## Memorandum

Winnetka Park District

Subject: Special Use Permit Review #1 – Centennial Park + Beach 255 Sheridan Road – (Case No. 24-08-SU) Review Responses (WPD)

Layout Plan

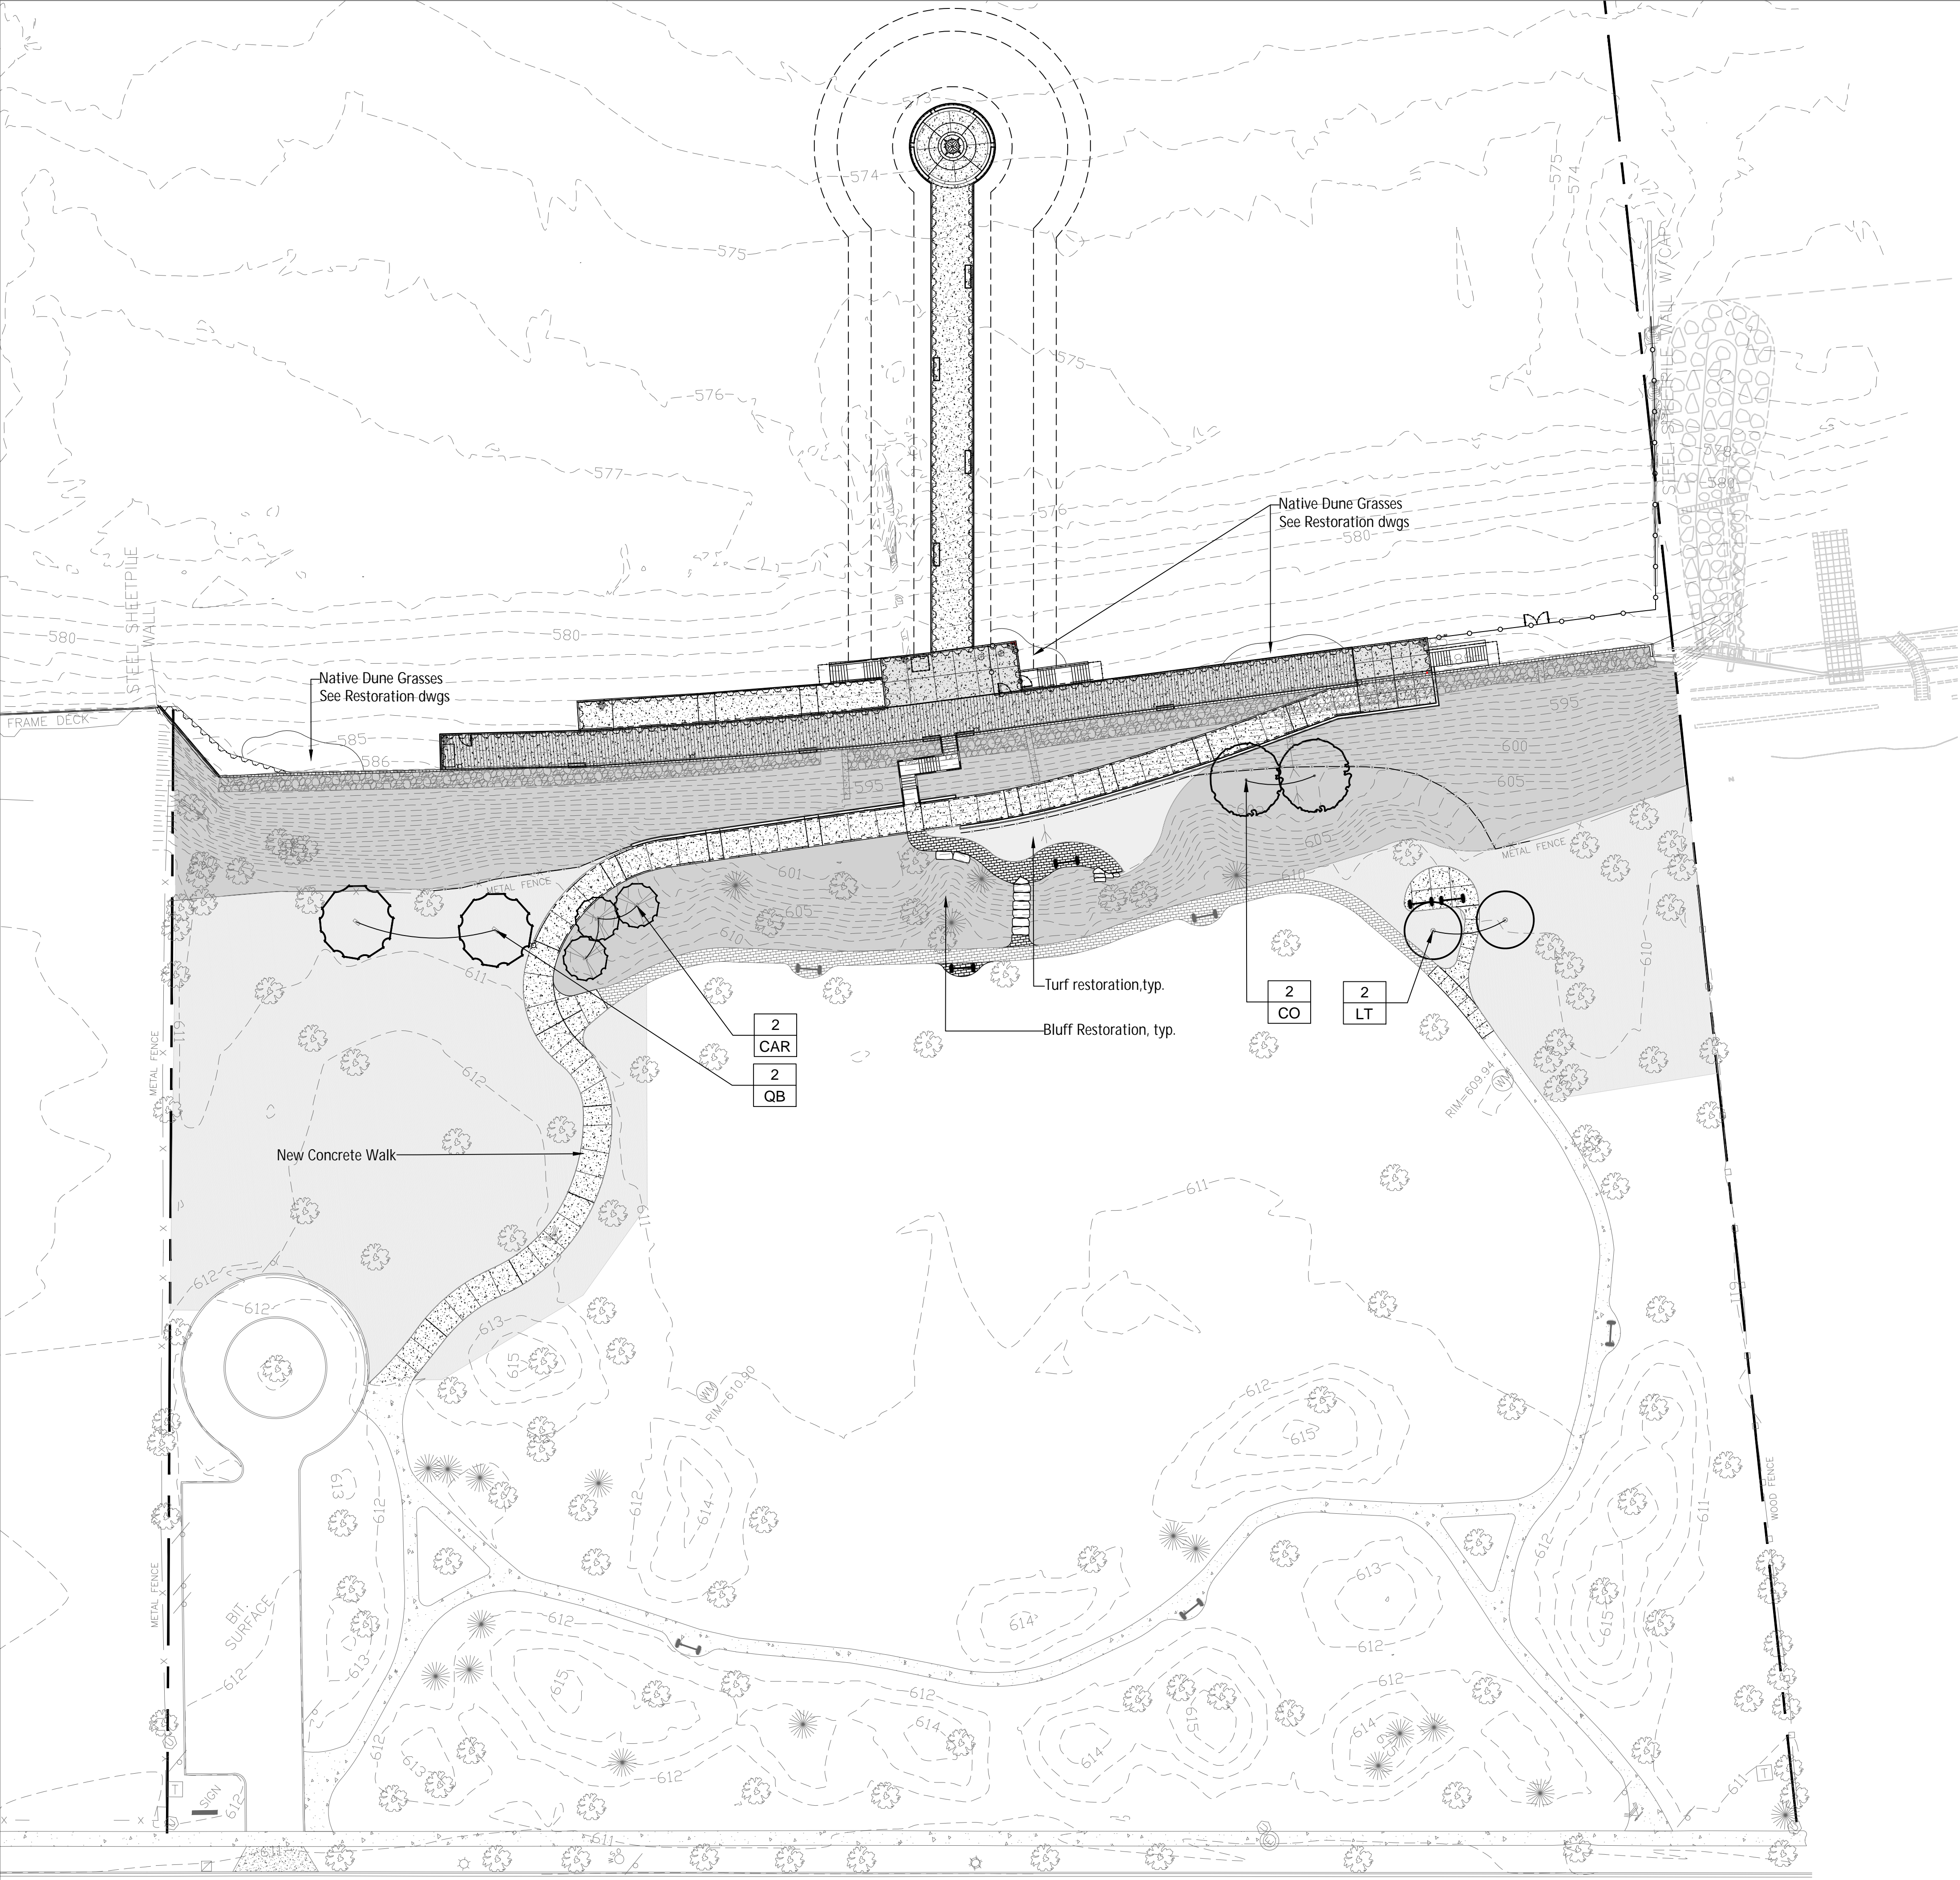
22. Fully dimension the plans. Including but not limited to the walks, boardwalk, ramp, width of pier, distance between the proposed dog beach fence and the new stone groin on the neighboring property.

11. Proposed fence around dog park, specifically along the southern end of the dog area, will need to be placed far enough away from the existing steel groin and new stone groin on neighboring property to allow for ample safe passage between the properties.

3. Provide minimum 42" clear path between ornamental dog beach fencing and rock wall on the southern portion of the beach property.

**Response: Fully dimensioned layout plan is provided, see sheet C138.**

**Response: The proposed dog beach fence is to be located on the existing steel groin to the south, offset 6' min. width from the new installed stone groin at the south neighbor property, as shown on sheet C138.**

**Response: The proposed dog beach fence is to be located on the existing steel groin to the south, offset 6' min. width from the new installed stone groin at the south neighbor property, as shown on sheet C138.**

C141

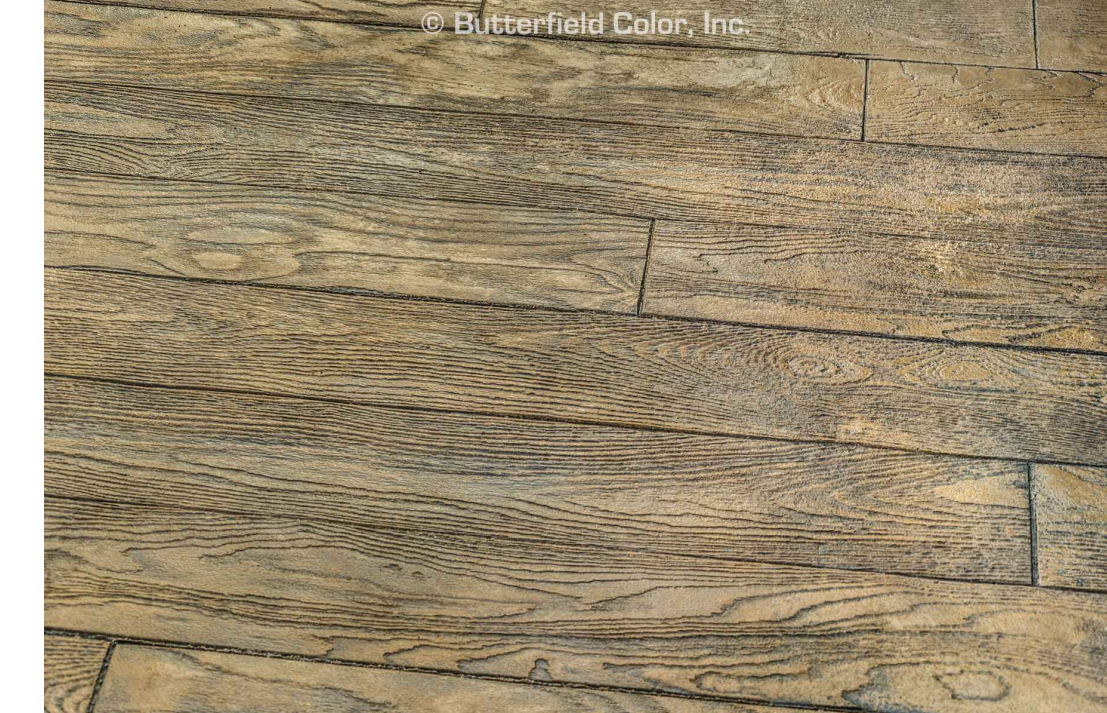
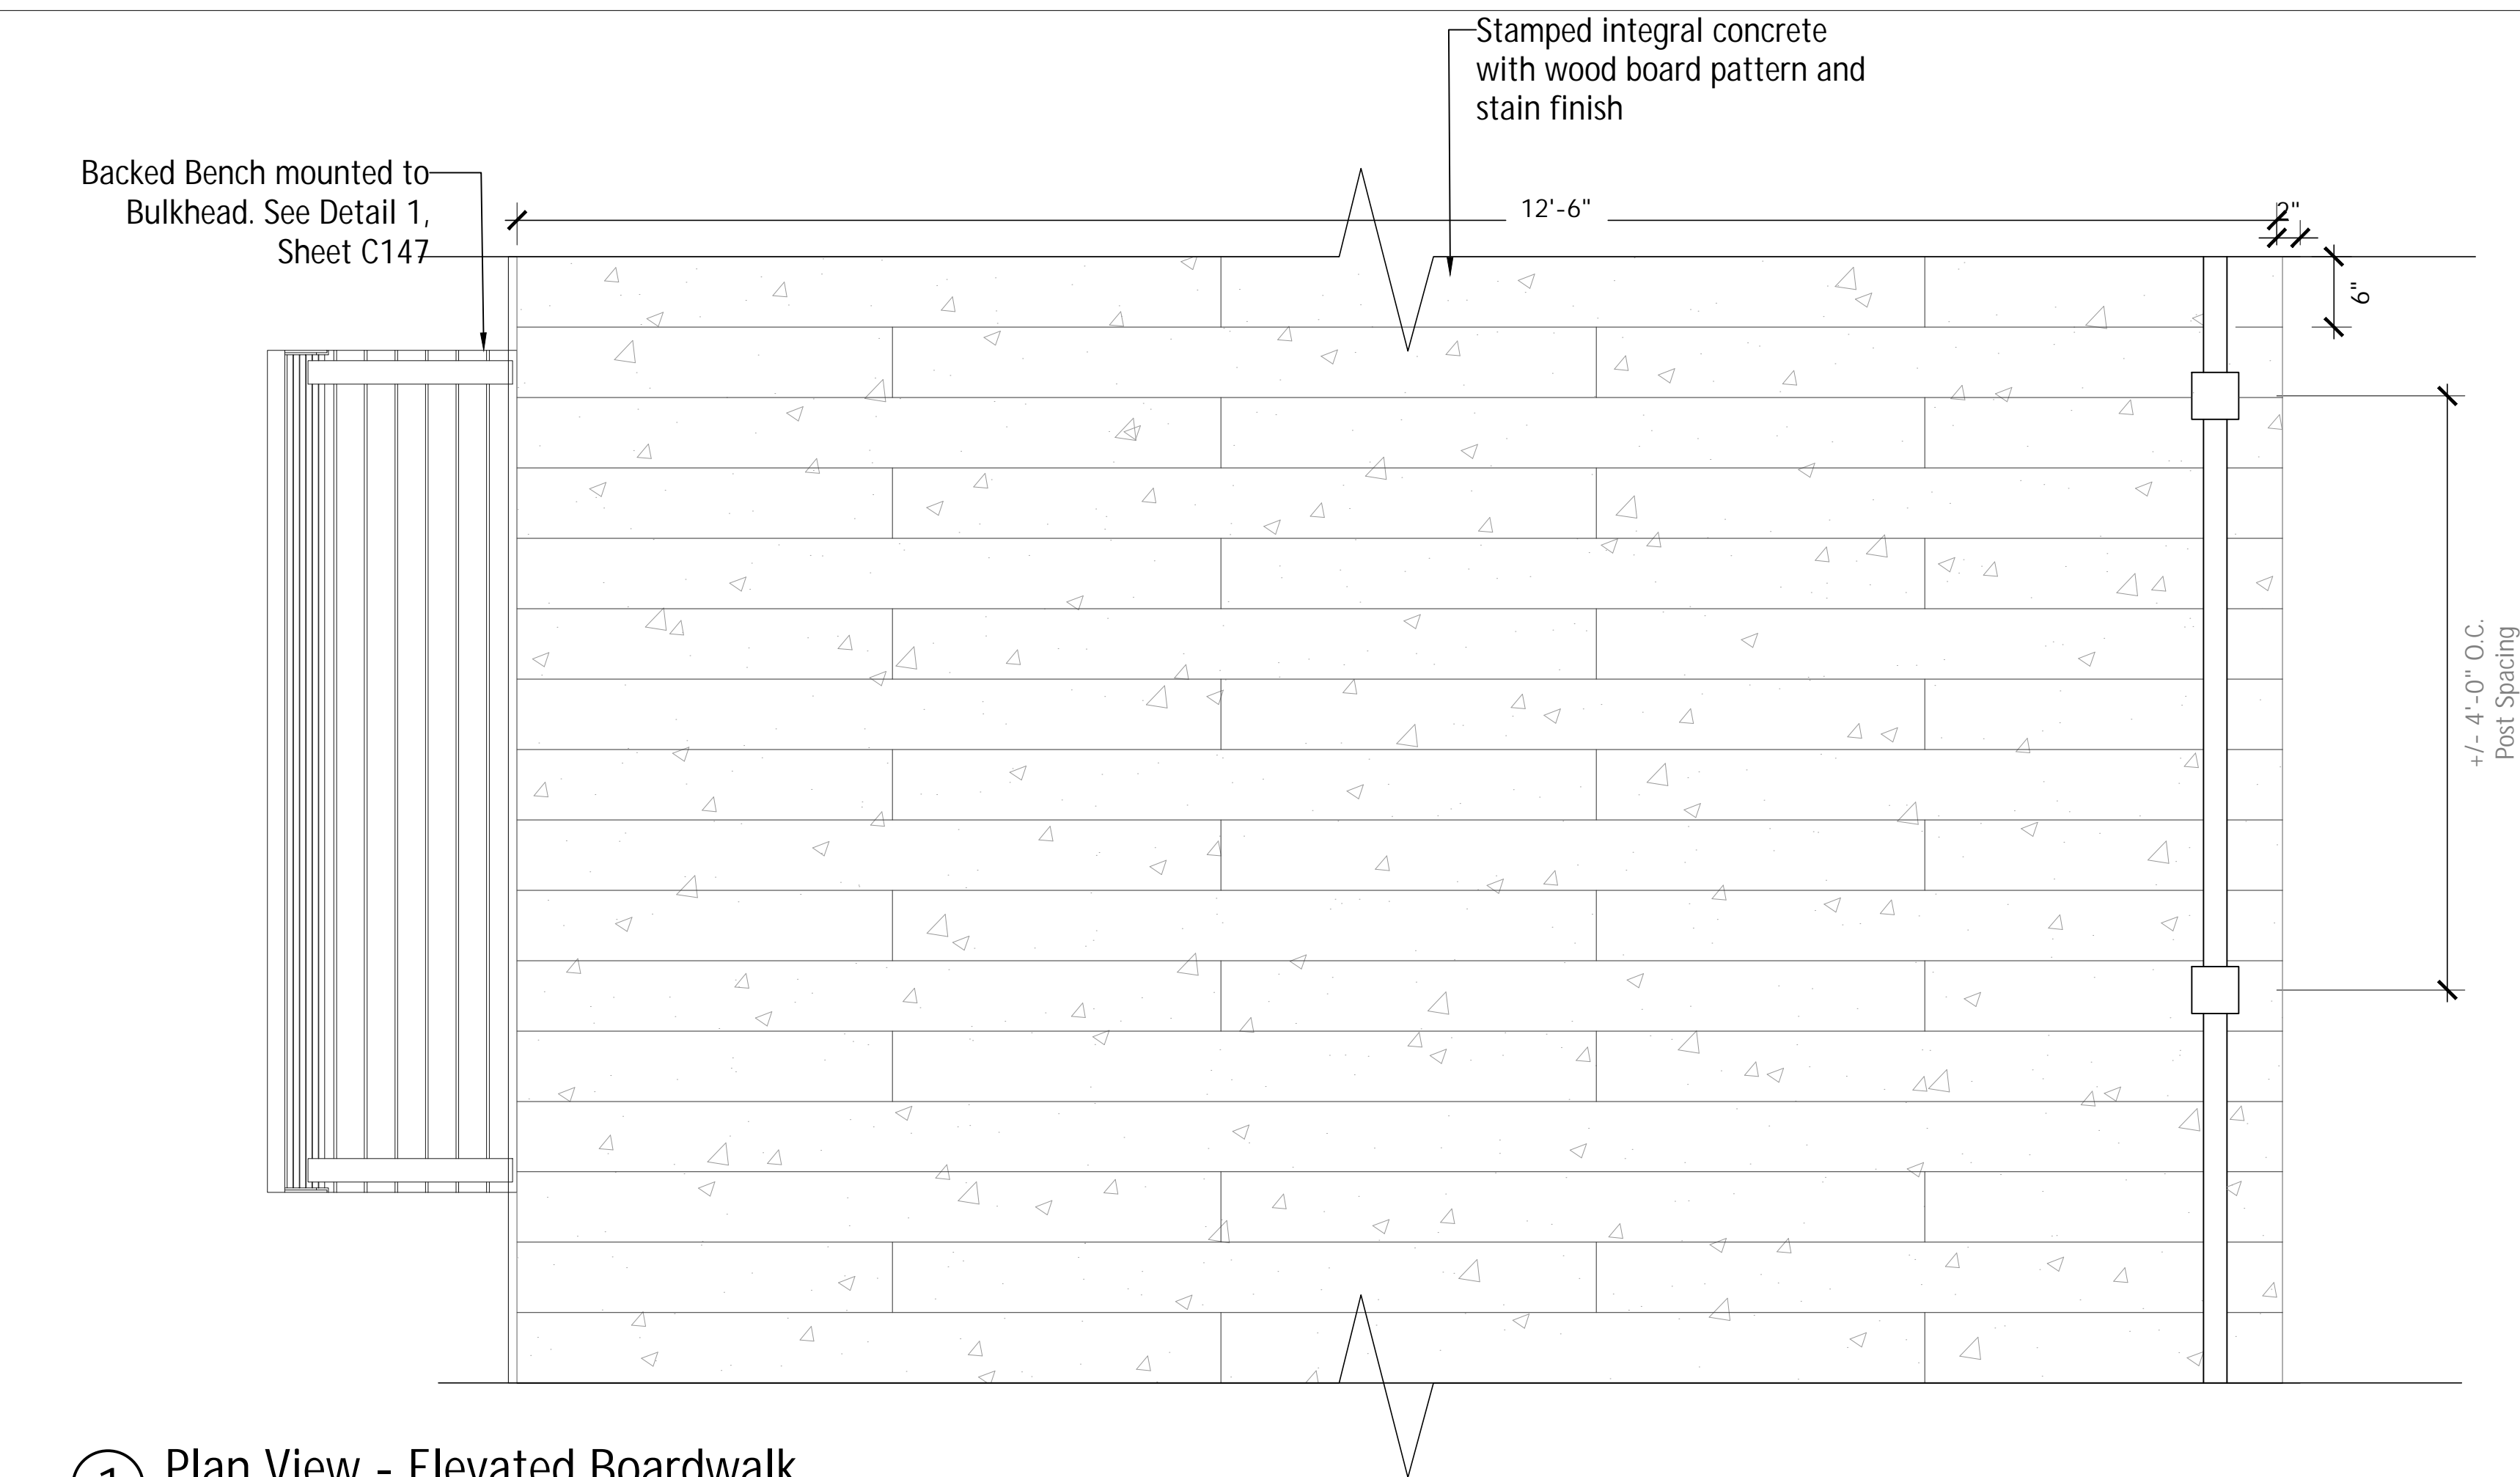
21. Please provide details (materials, finishes, colors, design etc.) of all proposed improvements (e.g. retaining walls, railings, fences, boardwalk, pilings, outcroppings, lighting, groin materials, etc.) so that the Zoning Board of Appeals will have a better understanding of the need for the required relief (variations and exceptions).

**Response: Details for sheet piles, groin materials, and retaining walls are provided on the engineer’s drawings. Details, materials, and cut sheets for site elements and improvements are provided on sheets C141-C148.**
